Re: Thomson River Weir Raising Project – RIDA Further Requirement Notice Response

RPI24/030: Longreach Regional Council – Thompson River Weir Project

Attachment C – Project full supply level

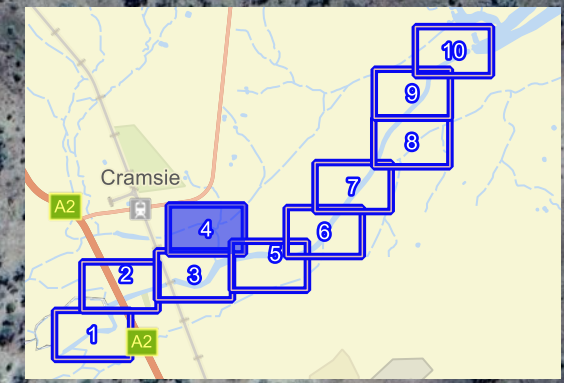
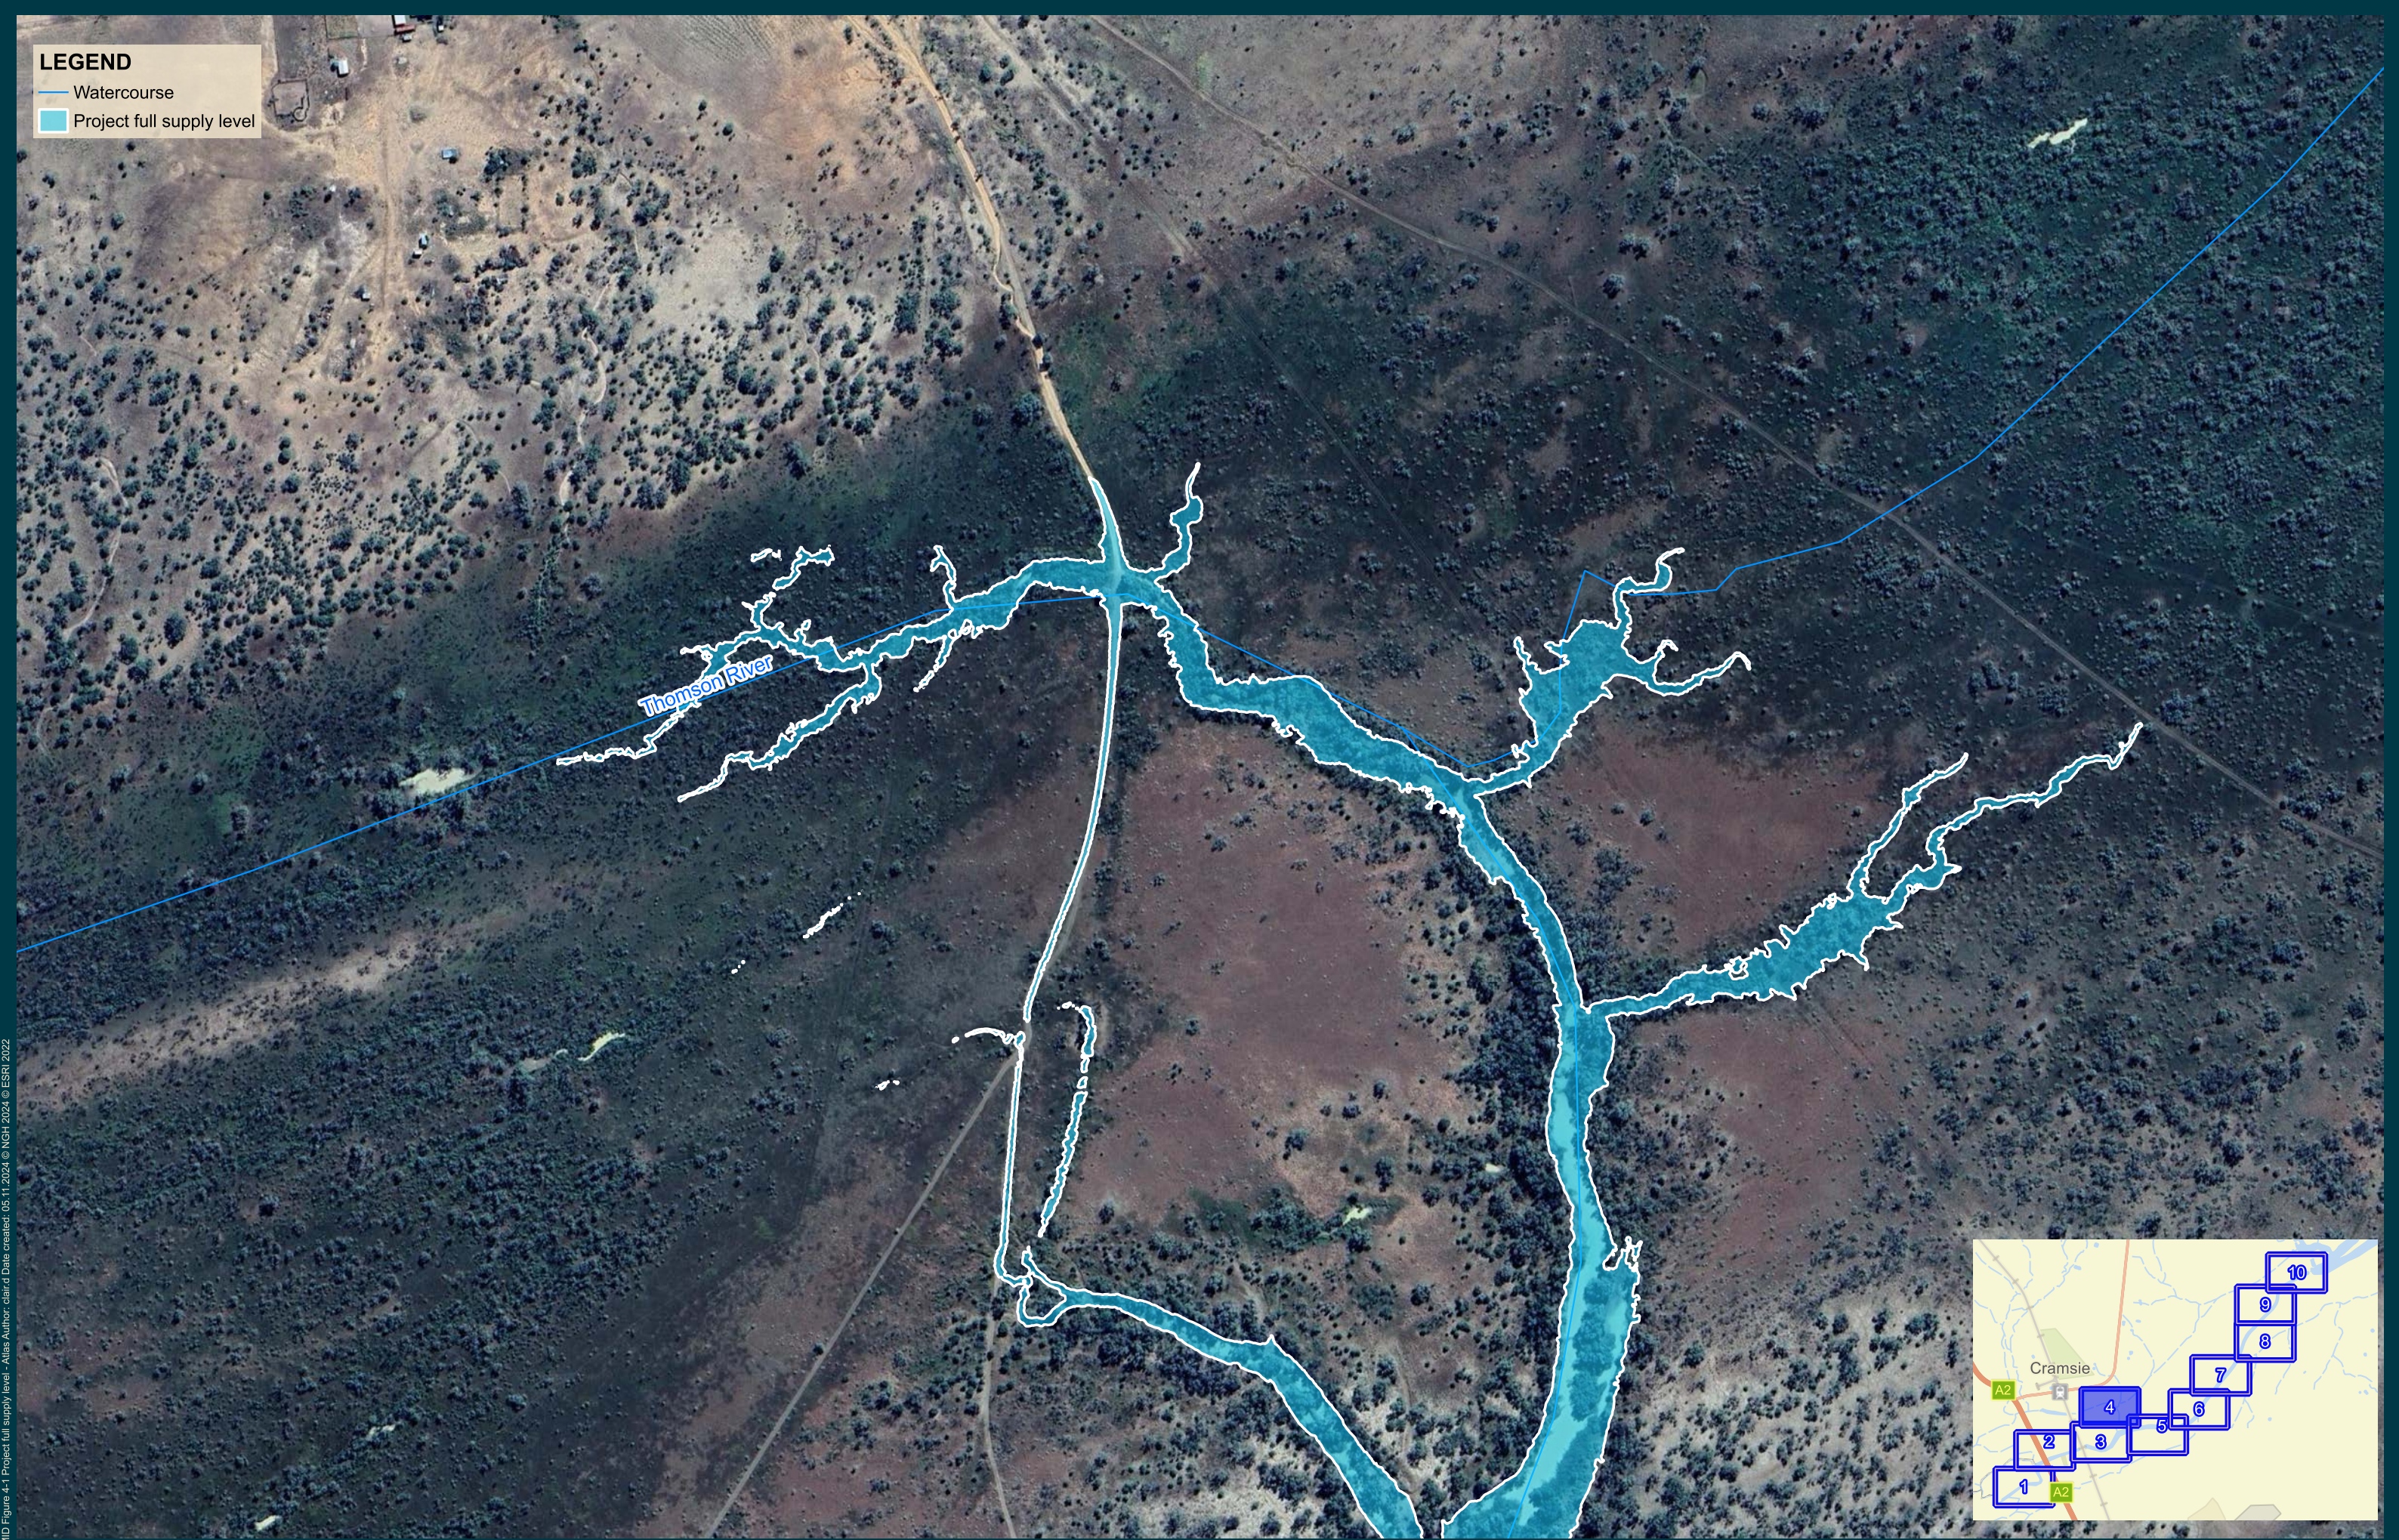
2.	<p><u>Issue:</u> The Requirement notice dated 15 February 2024 sought information on the extent of impacts on riparian vegetation due to increased inundation, however, the response indicated it was not possible to precisely determine the number and location of trees.</p> <p>In addition, the mapping indicates full supply level inundation but doesn't specify the additional flooding from the proposed one-metre upgrade to the five weirs. More details are required to assess the potential environmental impacts on the area and its riparian vegetation.</p> <p><u>Actions:</u></p> <ol style="list-style-type: none"> a) Provide mapping at a suitable scale that clearly shows the differences in spatial extent of area affected (additional inundation and less inundation) to result from the one metre weir upgrades, compared to the current situation and spatial extent. b) Provide details of the increased or decreased depth of inundation in the mapped areas in a) and period of time of the change in a typical year. c) Quantify in hectares, and map, the spatial extent of mapped areas in b) where existing riparian or other vegetation is not likely to survive the change to inundation.

The only significant change in the lateral extent of the FSL as a result of the Project will be in the anabranch to the north of the main channel (shown in Map 4 of Attachment C), where it is expected some smaller reaches of this anabranch will hold water when the storage is at full capacity. It is noted that this Anabranch is part of the Thomson River floodplain, and is mapped as a 'watercourse' under the *Water Act 2000*, and is an existing riparian area.

DSDIP Information requirement	Response
<p><i>Issue:</i></p> <p><i>The Requirement notice dated 15 February 2024 sought information on the extent of impacts on riparian vegetation due to increased inundation, however, the response indicated it was not possible to precisely determine the number and location of trees.</i></p> <p><i>In addition, the mapping indicates full supply level inundation but doesn't specify the additional flooding from the proposed one-metre upgrade to the five weirs. More details are required to assess the potential environmental impacts on the area and its riparian vegetation.</i></p> <p><i>Actions:</i></p> <p><i>a) Provide mapping at a suitable scale that clearly shows the differences in spatial extent of area affected (additional inundation and less inundation) to result from the one metre weir upgrades, compared to the current situation and spatial extent.</i></p>	<p>Attachment C includes a map set showing, at a finer scale than presented in the original RIDA application, the Project FSL. The <u>existing FSL</u> of the Town Storage extends from the existing weirs, 10 km upstream to the Fairmont Weir, and is visible in this figure in the aerial imagery base (beneath the transparent blue lens of the Project FSL). Attachment C shows clearly that the Project FSL will be similar in extent to the existing FSL of the Town Storage, and primarily contained the main channel of the Thomson River, as per existing Town Storage conditions. For clarity, the <u>Project FSL would also be constrained to the 10 km stretch between the weirs and the Fairmont Weir</u>, and there would not be an increase to the upstream extent of the water storage in the main channel.</p>
